SERVICE BULLETIN

SB1355A

ADDRESSEES	: Owners and operators of coaches listed under "Application"
VEHICLE MODEL	: CX45
SYSTEM/SUBSYSTEM	: 01.09 Complete vehicle - Automatic fire suppression system
BULLETIN TYPE	: Field Change Program
DATE	: September 08th, 2016
SUBJECT	: To change routing of extinguishing agent hose and check routing of linear detection wire
TERMS & CONDITIONS	: Refer to the warranty section further in this Bulletin

Figure 5

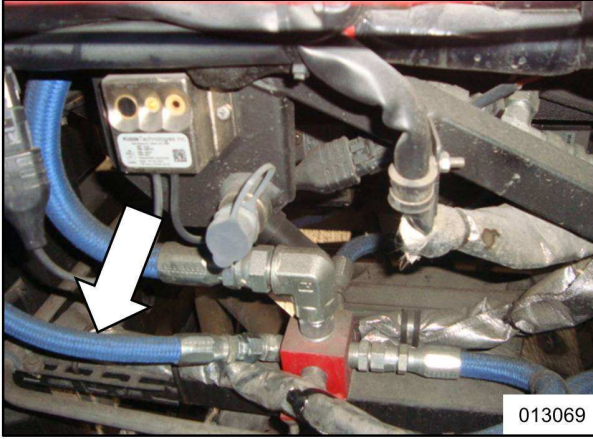
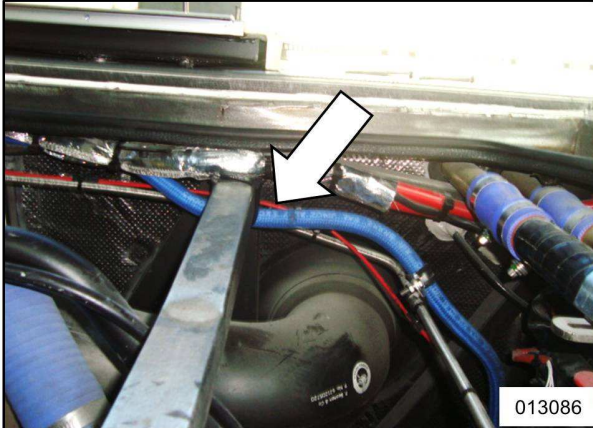
2.4

Connect the blue hose at the adaptor of the distributor block.

**Figure 7****3.4**

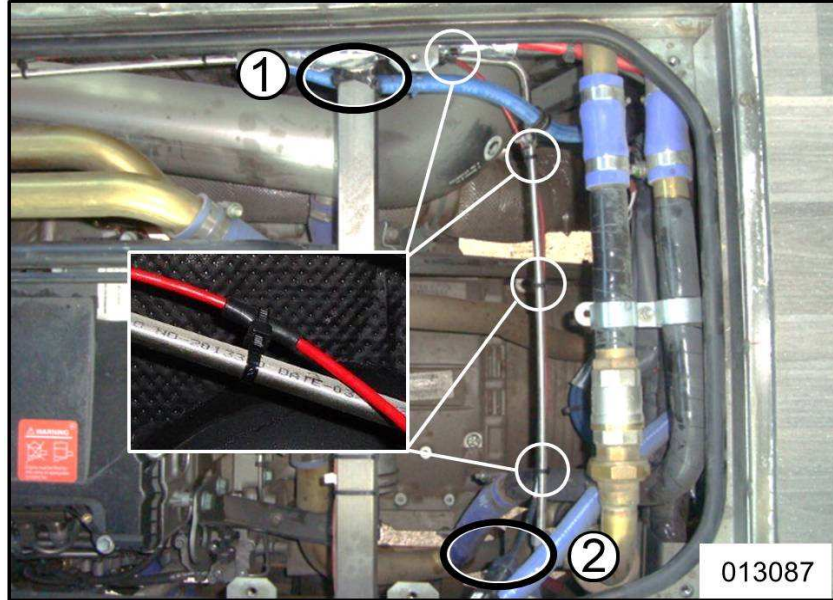
3.3

- Change the routing of the red linear detection wire as follows:
- Disconnect connector (2) of the red linear detection wire.
 - Remove the cable ties securing the red linear detection wire.
 - Route the red linear detection wire under cross-member (1).
 - Secure the linear detection wire with cable ties 660766565 from the kit.
